Chullora Materials Recycling Facility

Environmental Impact Statement (SSD-10401)

Appendix F Building Code of Australia Assessment Report

BCA ASSESSMENT REPORT

Figure 4 – Site Plan with FRNSW Access Road Mark-up's (Source: Envision Group Pty Ltd)

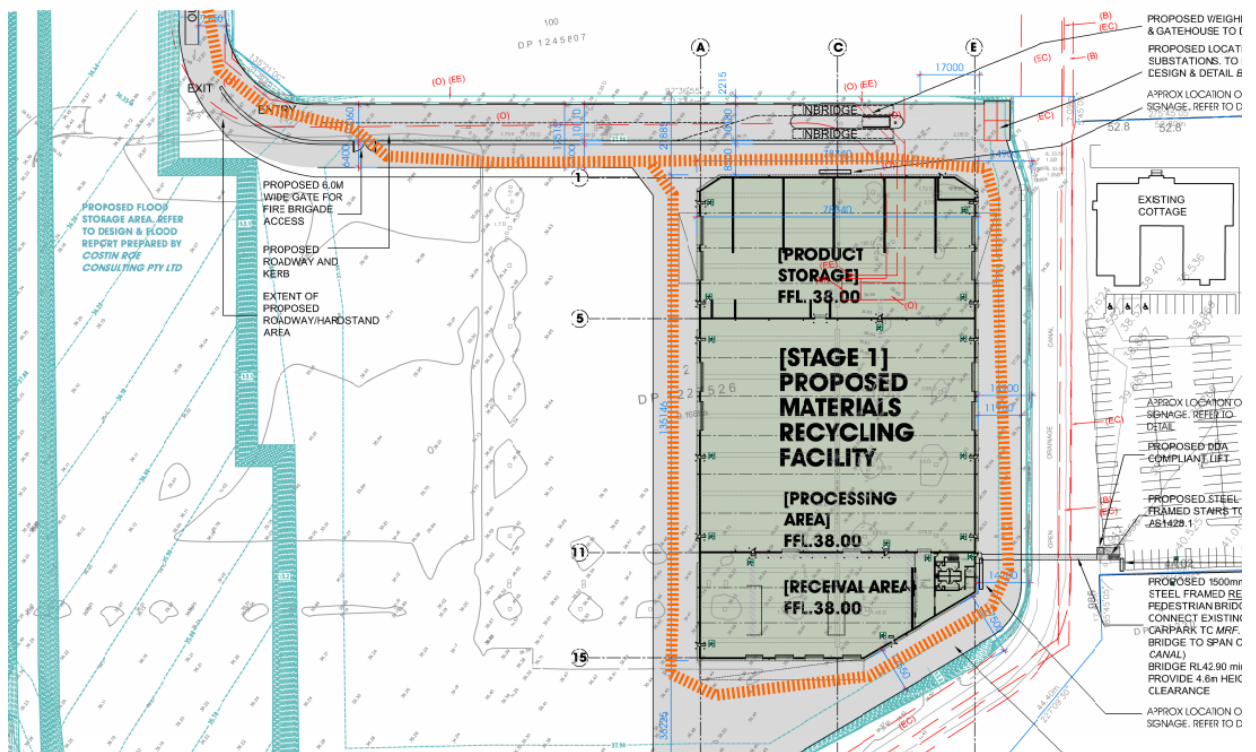
In this regard, the following areas have been identified as matters which may be requiring consideration by either way of design change or justification by the project Fire Safety Engineer;

- b) External Hardstand – Where external stock piling is proposed, the perimeter access roads are to be line marked to ensure they are maintained at all times and the perimeter access roads should be designed with enhances provisions to cater for large emergency services response (e.g. Multiple alarm and multiple agency attendance – including protracted Hazardous extraction response for the containment and removal of contaminated fire water run off). The hardstand areas above the flood basin areas are to be designed to accommodate the loads of fire brigade appliances or be restricted from access with permanent barriers and signage,

- d) Warehouse Building A (Overhead Bridge/Walkway) – The required 6m perimeter access road necessitated passing underneath the proposed overhead walkway/bridge structure proposed to connect the offices along the Eastern side and the heights are to achieve a minimum height of 4.5m,

- Refer to details below which detail perimeter vehicular access routes around the Building.

Fire Engineered Performance Solution: Notwithstanding the above, it is understood that the design team will obtain a Performance Based Solution prepared by a Fire Safety Engineer to rationalise the proposed vehicular access departures accordingly. In this regard, the report will need to demonstrate compliance with BCA Performance Requirement CP9 and be prepared to the satisfaction of the Registered Certifier and Fire & Rescue NSW at the Construction Certificate stages.
